PRELIMINARY SITE PLAN-SHEETZ UPWARD RD (26-01-SPR)

CITY OF HENDERSONVILLE - COMMUNITY DEVELOPMENT STAFF REPORT

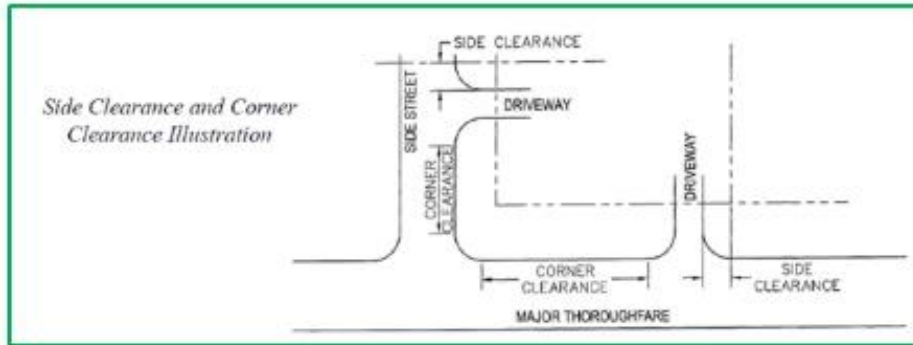
3. Corner clearance between Upward Rd and right-in entrance proposed on new access street is 80’. Minimum Corner Clearance for side street is 100’ from the point of tangency of the radius curvature of the intersection streets. Furthermore, the insufficient corner clearance would be exacerbated by future construction of a roundabout at Upward Rd @ Ballenger Rd. Applicant intends to seek a variance for this deficiency from the Board of Appeals.

b) All driveway approaches for both mid-block and corner lots along major thoroughfares shall have both minimum corner and side clearances as below:

Clearance Type	Along Major Thoroughfare	Along Side Street
Corner clearance ²	250 feet	100 feet
Side clearance ³	30 feet	10 feet

² Corner clearance shall be measured from the point of tangency of the radius curvature of the intersection streets.

³ Side clearance shall represent the distance from the driveway to the side property line.
